ADMINISTRATIVE AMENDMENT (PD) ADD2022-00068

ADMINISTRATIVE AMENDMENT
LEE COUNTY, FLORIDA

SAVANNA LAKES PD AMENDMENT

AMENDED MASTER CONCEPT PLAN

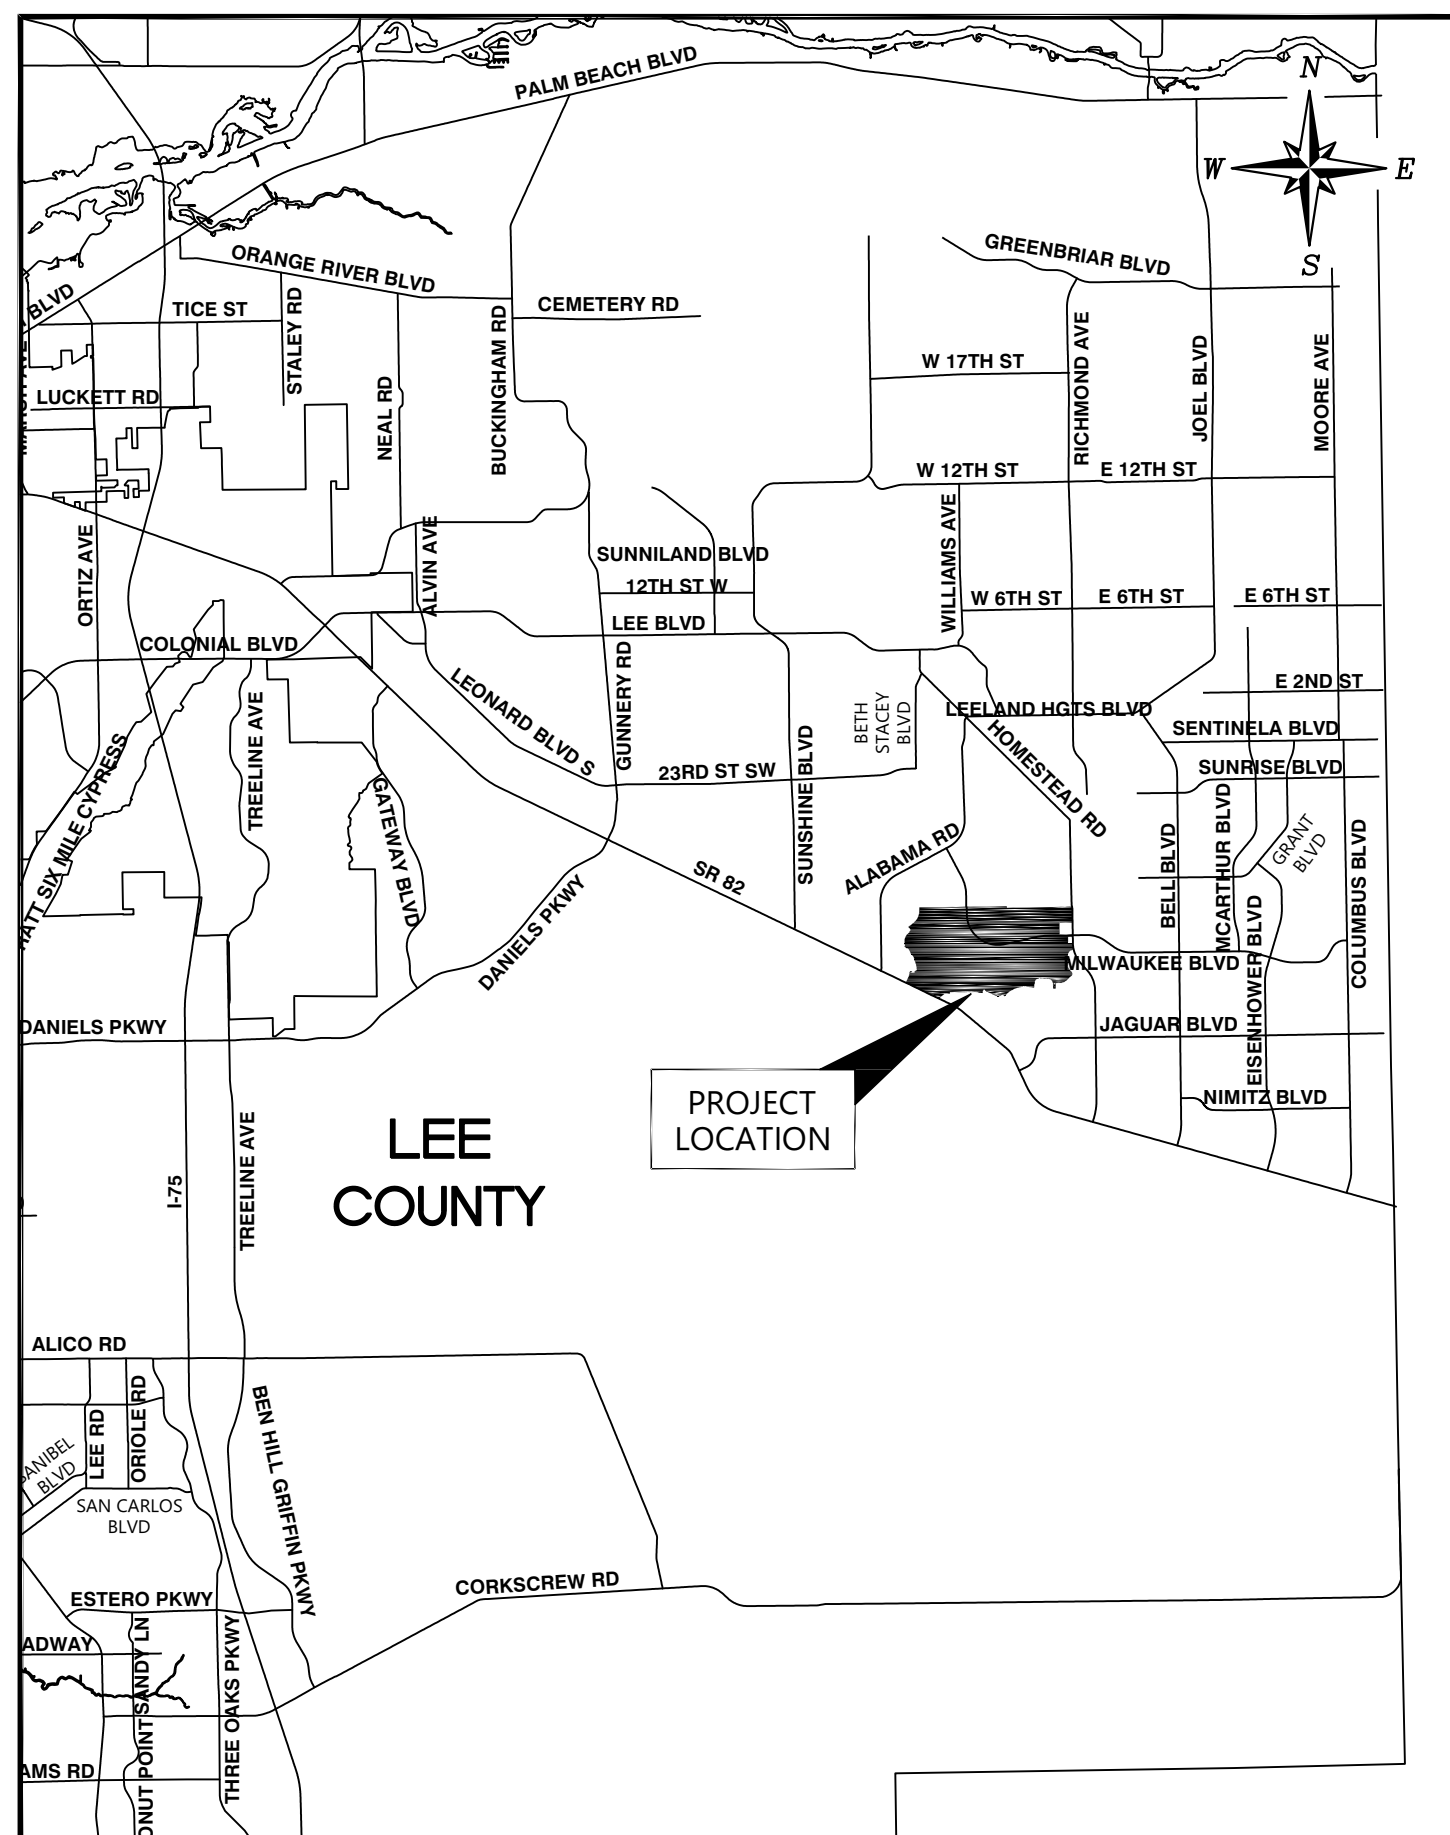
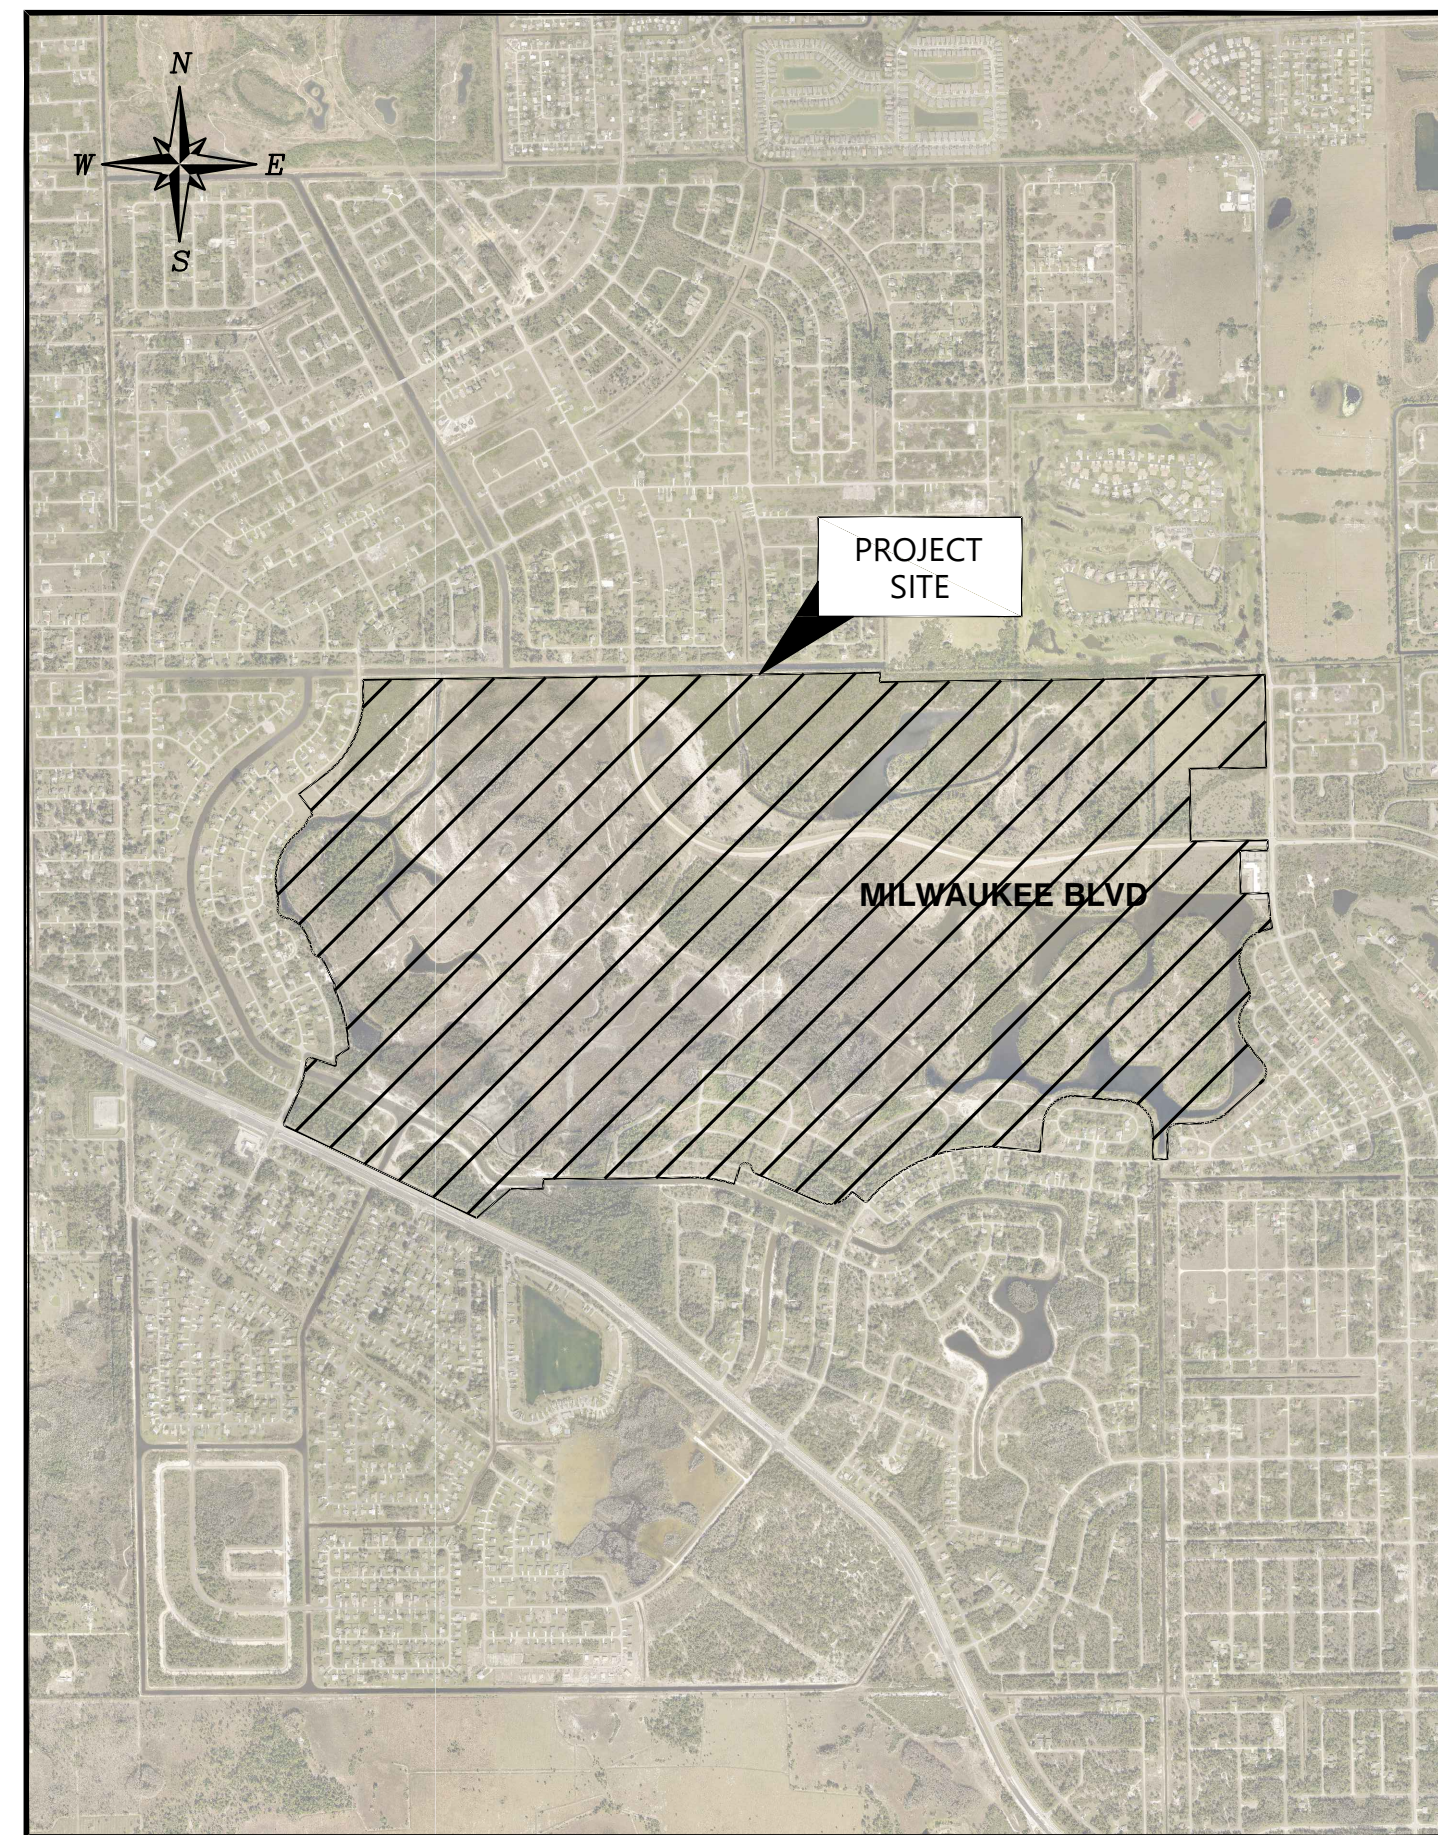
WHEREAS, the applicant has filed a request to amend the approved Master Concept Plan, specific to portions of Tracts A, H and I, in order to be consistent with the existing underlying Mirror Lakes Subdivision Plat approval within these respective tracts (see Exhibits "B" and "C"); and

WHEREAS, the amended master concept plan eliminates a segment of 25-foot-wide landscape buffer along the southern perimeter of the platted lots, in accordance with Condition 9 of Resolution Z-06-074 and Note #8 of the approved Master Concept Plan (see Exhibit “E”); and

WHEREAS, elimination of the buffer results in a decrease in open space of 8 acres, which is equivalent to a 2.1 percent decrease overall (378.1 acres from 386.1 acres); and

The area within Tract A maintains the minimum 25' buffer requirement between the proposed roadway and the PUD boundary. Within Tracts H and I, no buffers are proposed (See notation on revised MCP) since buffers are not required for single-family residential tracts adjacent to either existing roadways, a canal, or residential lot(s). This proposed change is consistent with existing Condition #9 under Resolution Z-06-074 and Note #8 on the MCP that no buffering is required for single-family uses; as well as providing for consistency with LDC Sec. 10-416.d.3 that buffers between proposed single-family uses and existing

- 1. The development must be in substantial compliance with the three-page amended Master Concept Plan entitled “Master Concept Plan for Savanna Lakes”, dated March of 2022, attached hereto as Exhibit “B.”**

2. **Multi-family dwelling unit types may not be located within the specific to portions of Tracts A, H and I affected by this amendment.**
3. **The terms and conditions of the original zoning resolution, and subsequent amendments thereto, remain in full force and effect, except as amended herein.**
4. **If it is determined that inaccurate or misleading information was provided to the County or if this decision does not comply with the LDC when rendered, then, at any time, the Zoning Manager may issue a modified decision that complies with the Code or revoke the decision. If the approval is revoked, the applicant may acquire the necessary approvals by filing an application for public hearing in accordance with Chapter 34.**

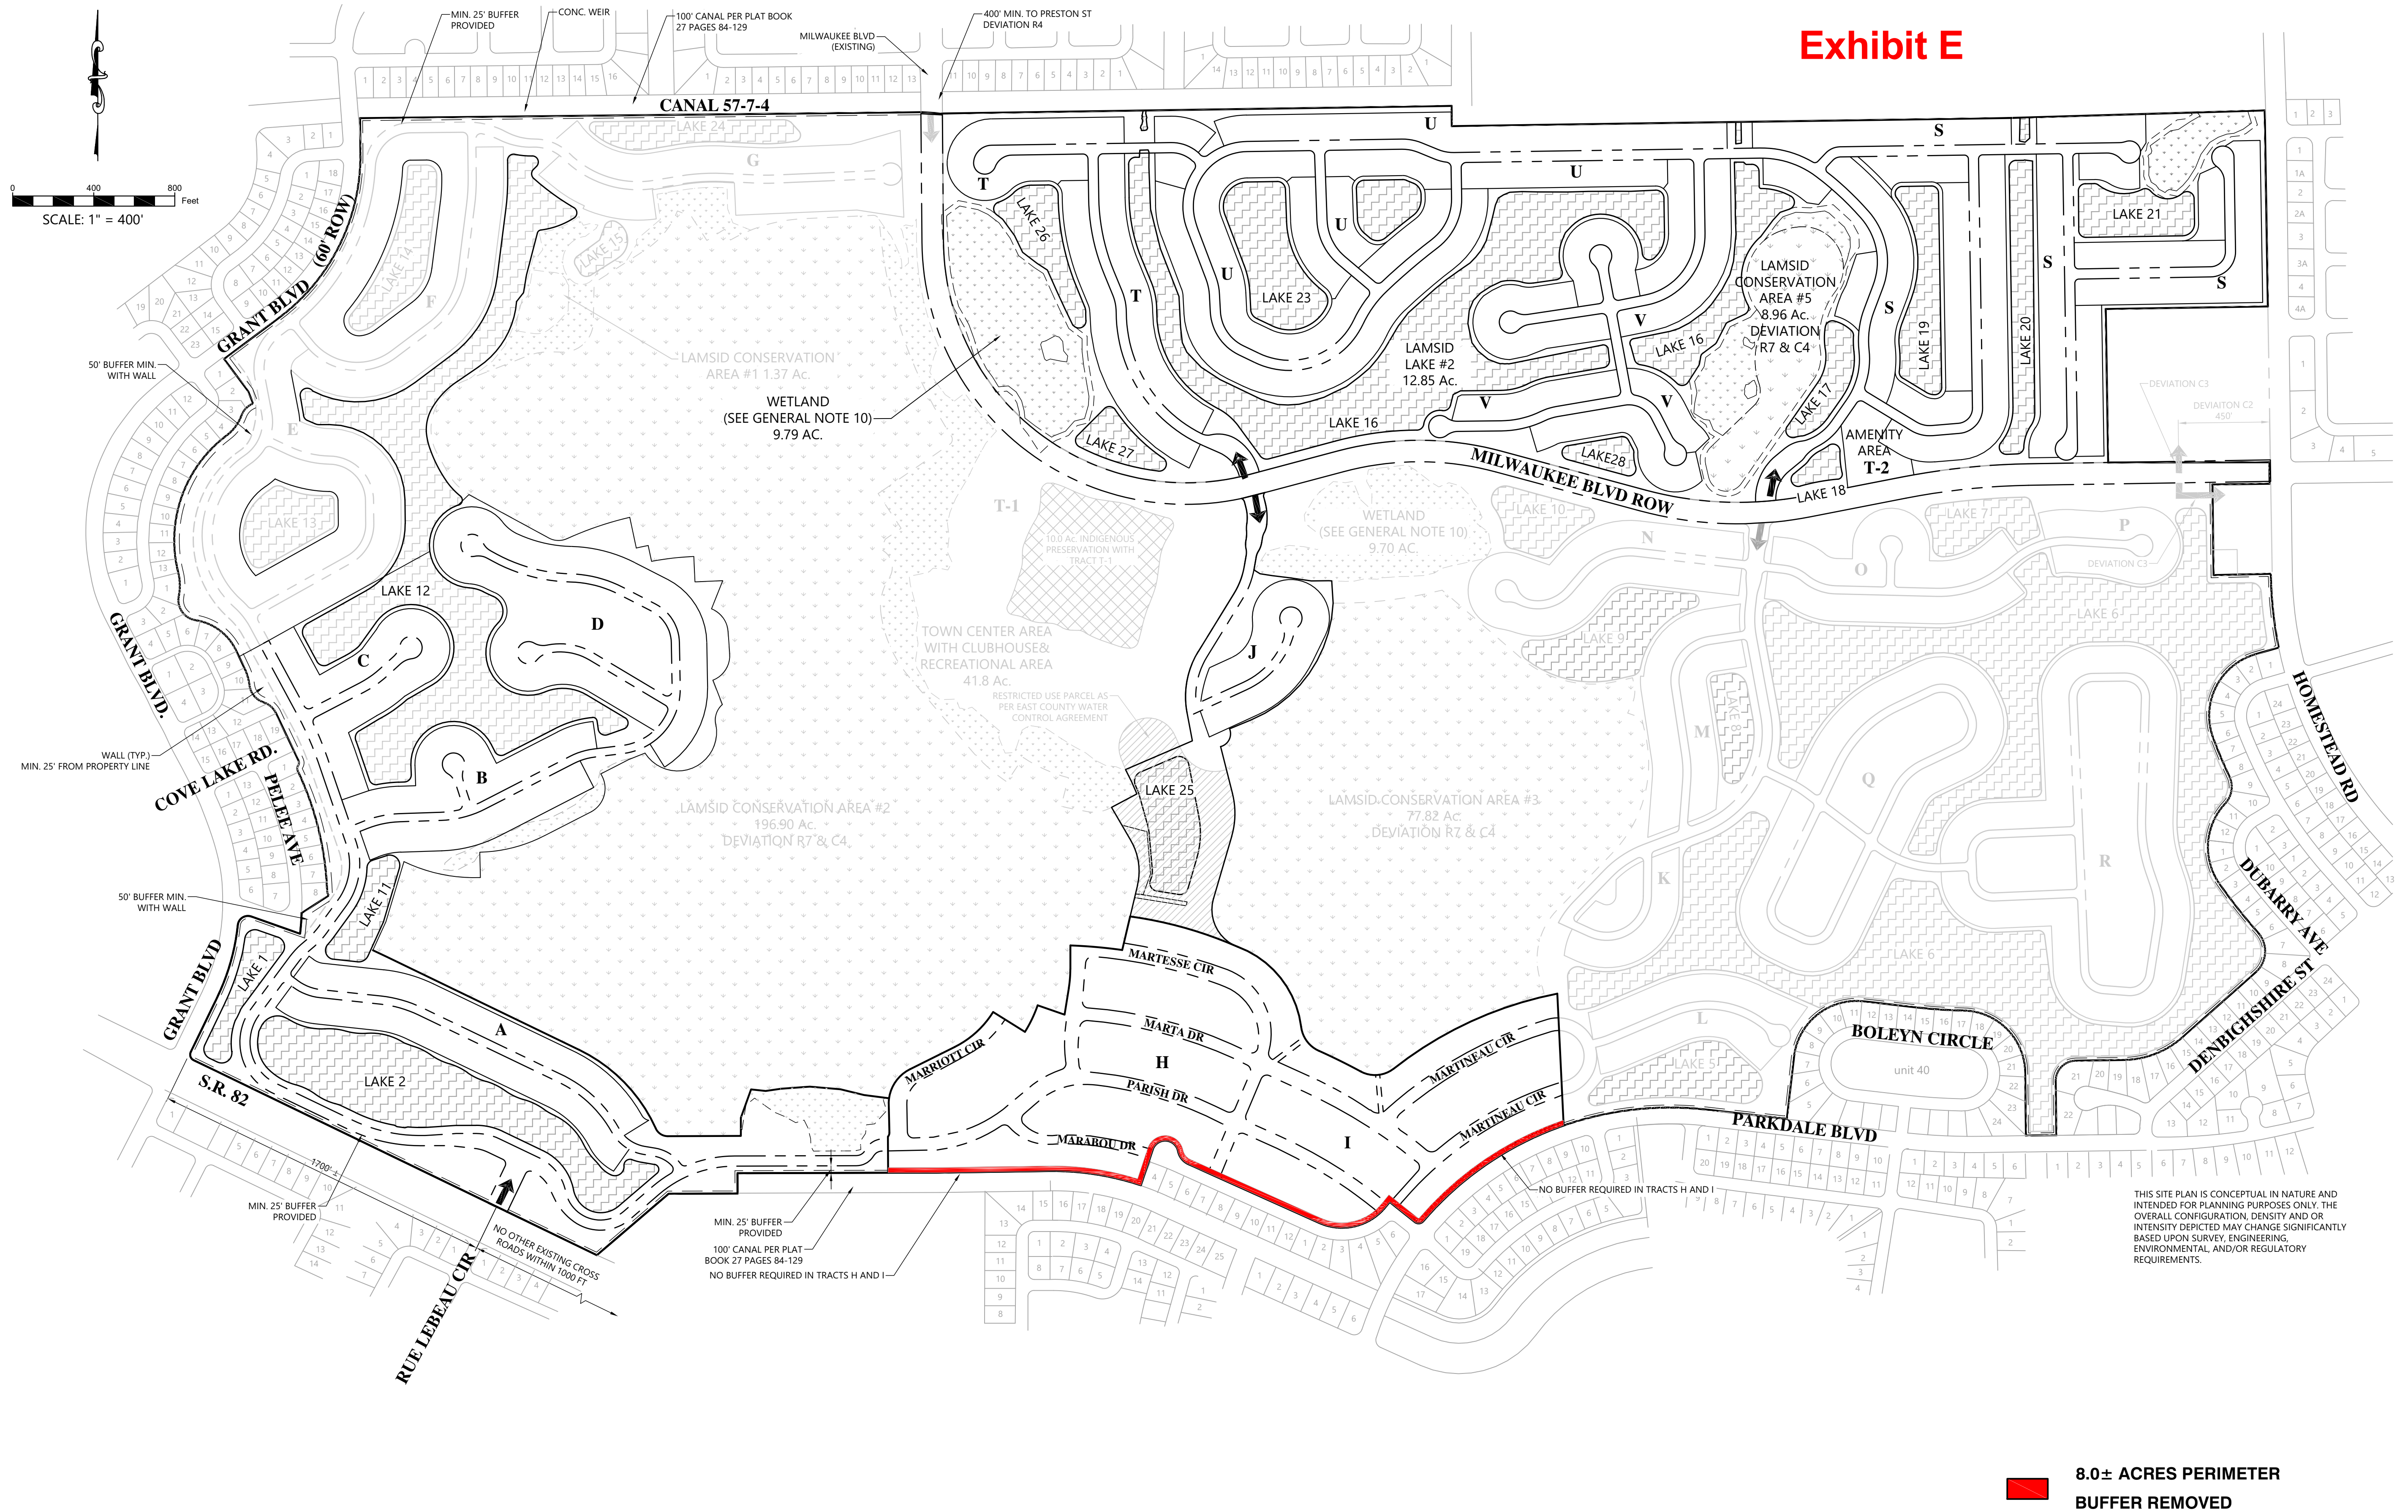
**8.0± ACRES PERIMETER
BUFFER REMOVED**
